# UNITED STATES PATENT AND TRADEMARK OFFICE

APPLICATION NO.	FILING DATE	FIRST NAMED INVENTOR	ATTORNEY DOCKET NO.	CONFIRMATION NO.
10/677,816	10/02/2003	Dwight Jerome Holter		9791

<b>Office Action Summary</b>	<b>Application No.</b> 10/677,816	<b>Applicant(s)</b> HOLTER, DWIGHT JEROME	
	<b>Examiner</b> Michael G. Bogart	<b>Art Unit</b> 3761

## **DETAILED ACTION**

FIG. 3FIG. 2

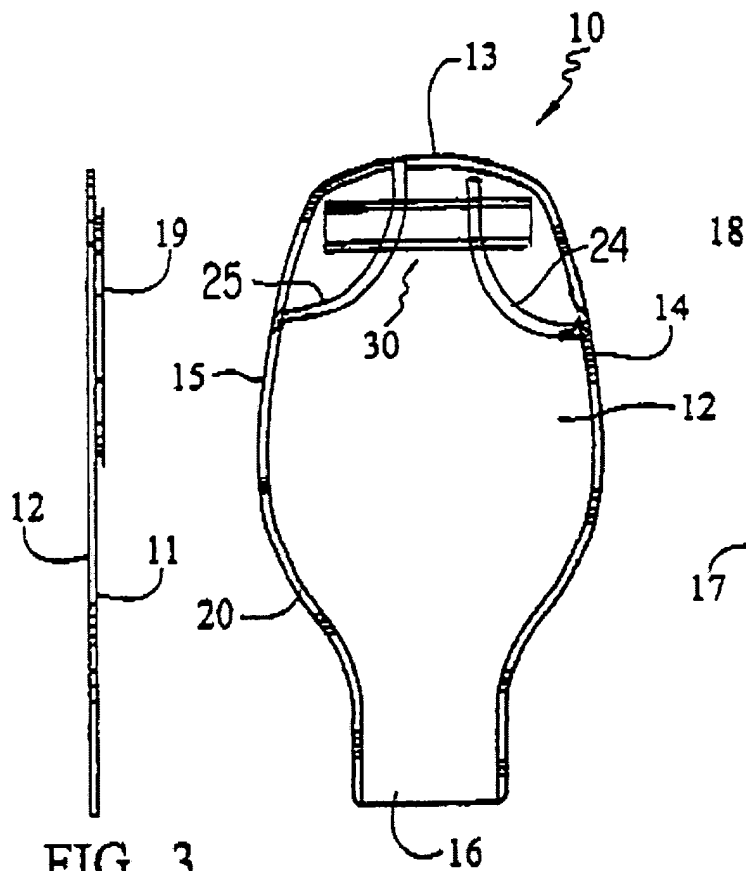
Regarding claim 10, Holtermann *et al.* teach an ostomy bag (10) comprising: (A) a main bag chamber (11, 12) having an upper extremity; (B) a multipurpose latent (hidden) tube (30)

with said main bag chamber (11, 12), said latent tube (30) having a proximal end (34) attached to and opening to said main bag chamber (11, 12) upper extremity and providing the capability for fluid communication with said upper extremity, said tube (30) also having; (1) a distal end (35); and (2) significant latent tube length between said proximal end and said distal end; at least a substantial part of said length being parallel to and separably attached to said main bag chamber (11, 12)(see fig. 2, below).

Holtermann *et al.* do not expressly disclose that the tube and ostomy bag are co-formed.

Regarding the limitation of the instant invention that the tube is separable from the ostomy bag, one taking apart the bag could separate the tube from the bag.

**Fig. 3.**

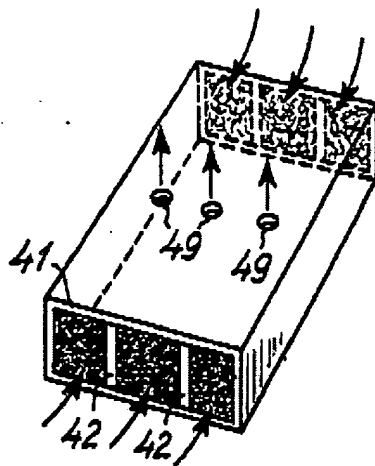
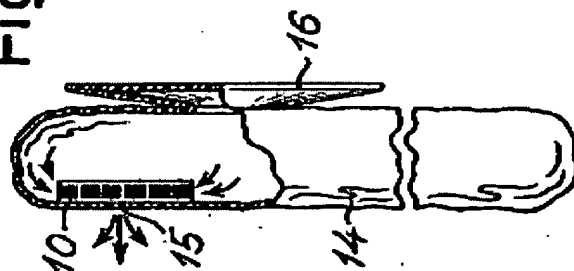
Regarding claim, 17, Moller teaches a stomal waste management system comprising multiple use latent tubing (41) having: (a) front and back walls comprising thin, flexible, water impermeable plastic, said latent tubing (41) further having at least one channel having a flat width dimension and at least two end openings, at least one of said openings being a proximal end through which gas can enter said tube, which latent tubing (41) takes tubular form as necessary for gas flow therethrough, and wherein said latent tubing (41) has at least one pair of spaced apertures (49) in one of its walls to accommodate attachment of a filter (37) with appropriately mating apertures (interstices in the filter web), said latent tubing (41) further having at least one interval seal (14) to route gas into said filter (37)(see figs. 3 and 10, below).

Moller does not teach the specific width dimension of the instant invention.

Regarding claim 18, Moller does not expressly disclose a plurality of pairs of apertures. Merely modifying the range of numbers of an element is not sufficient to patentably distinguish an invention over the prior art. MPEP § 2144.04.
